Subject: AP1000 Responses to Requests for Additional Information (SRP 6)

Response to Request for Additional Information on SRP Section 6

RAI Response Number: RAI-SRP6.2.2-SPCV-04
Revision: 2

Figure 6.2.2-1 (Sheet 1 of 2)

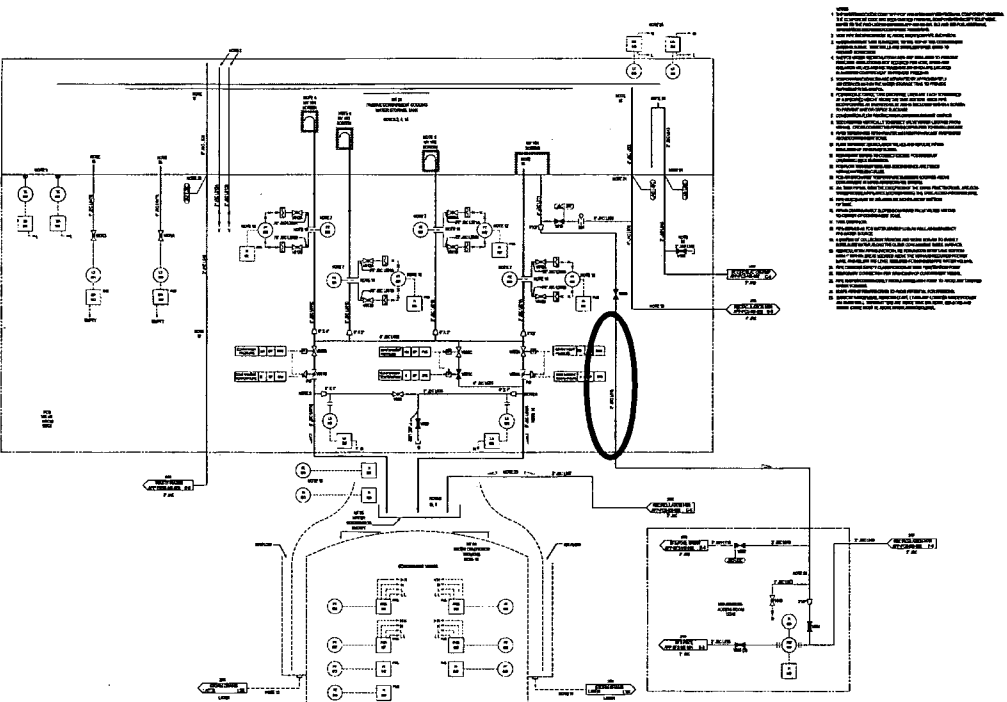
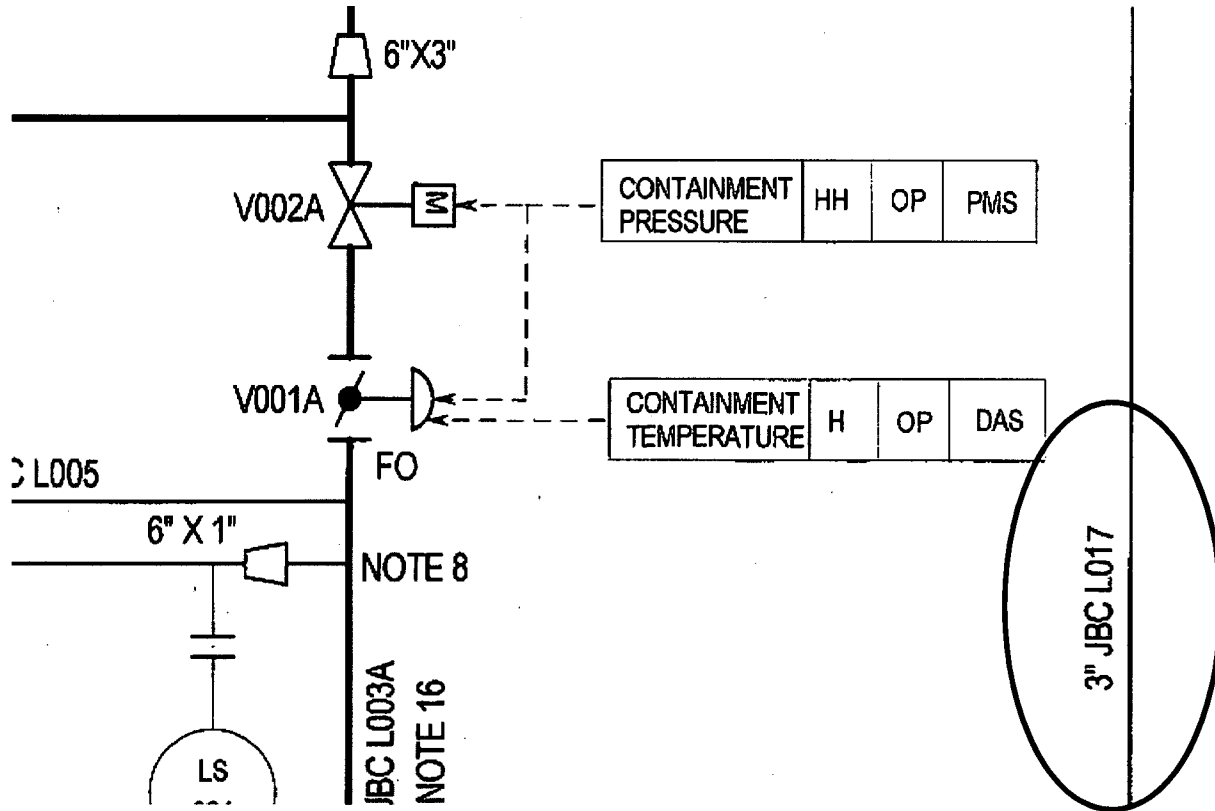
In DCD Tier 1 Table 2.2.2-2, the Line Numbers identified for the last two rows are not consistent with the changes made to Figure 6.2.2-1. Describe any corrections, if necessary, to Table 2.2.2-2.

In response to RAI-SRP6.2.2-SPCV-04, Westinghouse states Tier 1 Table 2.2.2-2 does not have to be changed to reflect changes made to the PCS P&ID (Figure 6.2.2-1 Sh 1 of 2). From Figure 6.2.2-1, it appears that PCS-PL-L048 should be included in Tier 1 Table 2.2.2-2, "Post 72 hr PCCWST Makeup Supply lines," and PCS-PL-L011 should be included in Tier 1 Table 2.2.2-2, "Post 72 hr SFS Makeup Line." For each of these lines, provide an explanation why they should not be included.

The line number for PCS makeup to the spent fuel pool is incorrectly numbered as shown in Figure 6.2.2-1 (Sheet 1 of 2). A DCD revision is required to replace the line PCS-PL-L018 with PCS-PL-L017 in Figure 6.2.2-1 (Sheet 1 of 2). The physical line itself remains the same only the numbering changes. The revision to the DCD is occurring in Tier 2 information NOT Tier 1 information.

PCS-PL-L018 is replaced by PCS-PL-L017 on the attached PCS P&ID and detail (Figure 6.2.2-1 Sh 1 of 2).

Circled area shows the markup to occur on Figure 6.2.2-1 (Sheet 1 of 2).
